Make a Planning Appeal

WEBLRD6093/26-S3B

MILLTOWN PARK, SANDFORD ROAD,
DUBLIN 6,
Dublin
D06 V9K7
Ireland

Third Party planning appeal in respect of the decision of Dublin City Council to issue Notification of Intention to Grant Planning Permission, under planning application, reg. ref. WEBLRD6093/26-S3B, for proposed development comprising of: "... a large-scale residential development ... The development will principally consist of: "the demolition of c. 4,847.5 sq m of existing structures on site including Milltown Park House (880 sq m), Milltown Park House Rear Extension (2,031 sq m), the Finlay Wing (622 sq m), the Archive (1,240 sq m) and the Link Building between Tabor House and Milltown Park House Rear Extension to the front of the Chapel (74.5 sq m); the refurbishment and reuse of Tabor House (1,575 sq m) and the Chapel (768 sq m) and the provision of a single storey glass entrance lobby to the front and side of the Chapel (52 sq m); and the provision of 562 No. residential units comprising 6 No. three-bed courtyard houses and 556 No. apartment units (70 No. studios, 176 No. one-bed units, 267 No. two-bed units and 43 No. three-bed units). Block A1 will range in height fr

Fig. 65: Block D's 3 storey section proposed shadow at 8am on June 21st

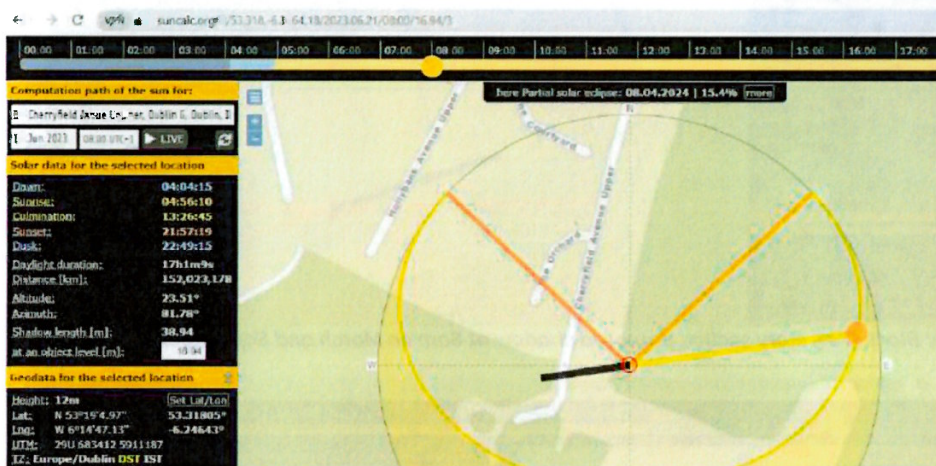
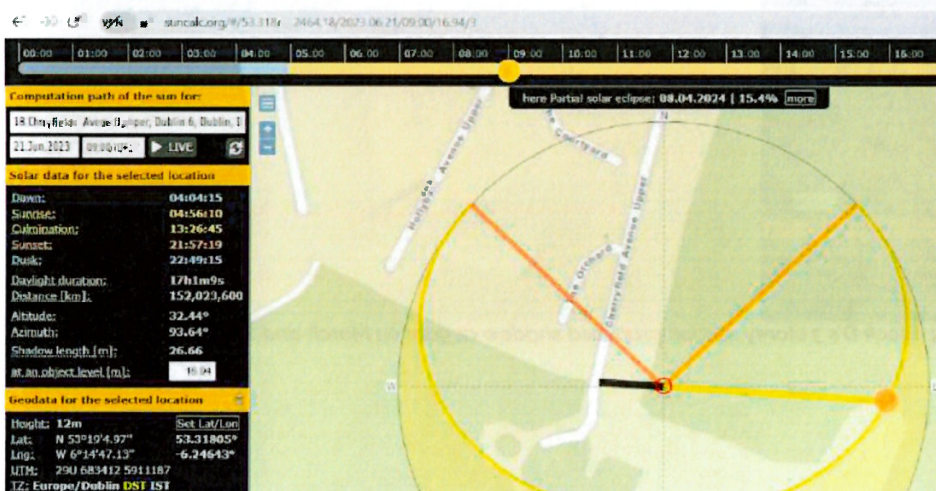
June 21st: From sunrise until nearly 10 am, Block D would cause overshadowing of our client's residents properties sited to the west, southwest and northwest. This overshadowing would impact private rear elevations and rear gardens. This overshadowing is not mitigated in any manner. The setting back of the 3rd storey and removal of the 4th and 5th would mitigate much of the overshadowing such that a fair overshadowing (morning/evening) balance between the opposing properties is achieved.

Fig. 67: Block D's 3 story section's proposed shadow at 10am on December 21st

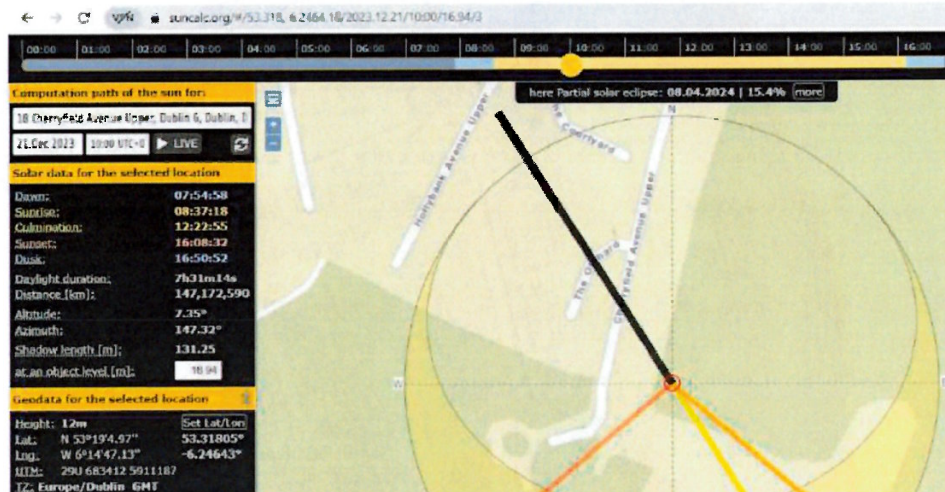
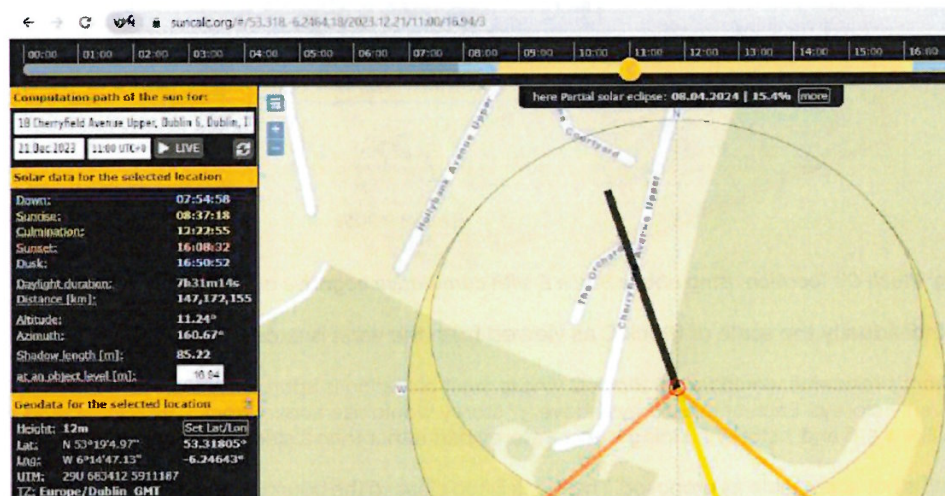
December 21st: From sunrise until nearly noon, Block D would cause overshadowing of our client's residents properties sited to the west, southwest and northwest. This overshadowing would impact private rear elevations and rear gardens. This overshadowing is not mitigated in any manner. The setting back of the 3rd storey and removal of the 4th and 5th storeys would mitigate much of the overshadowing such that a fair overshadowing (morning/evening) balance between the opposing properties is achieved.

Fig. 105D: The yellow hatched area superimposed onto the proposed Tree Impact drawing shows the extent of tree losses proposed to facilitate Block E and a scheme service area to the south of the block

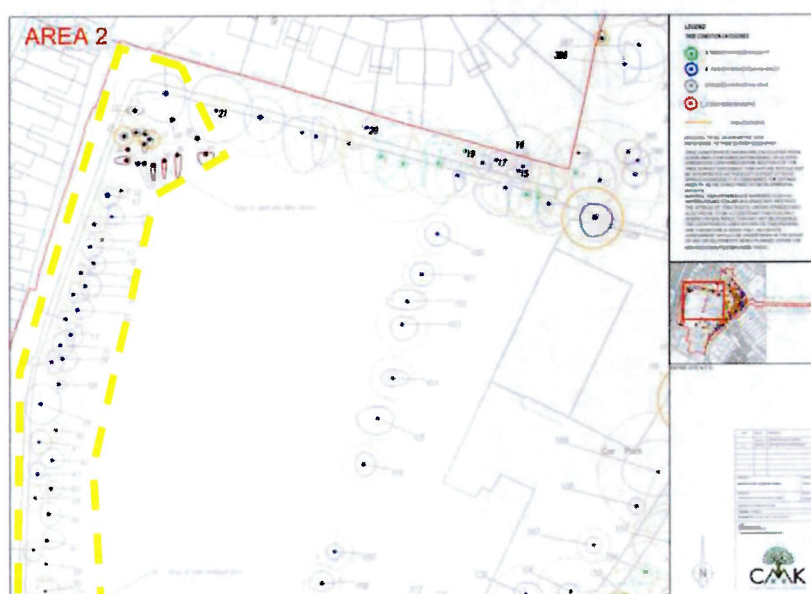
Fig. 105D is an excerpt from the Tree Impact Assessment drawing provided by the project Arborist. It confirms how a large number of trees – all those in blue and red bubbles – are proposed to be removed from the existing mature western tree belt to facilitate the installation of Block E and an area of carparking, bike parking, attenuation, vehicle turning, etc. to the south of Block E.
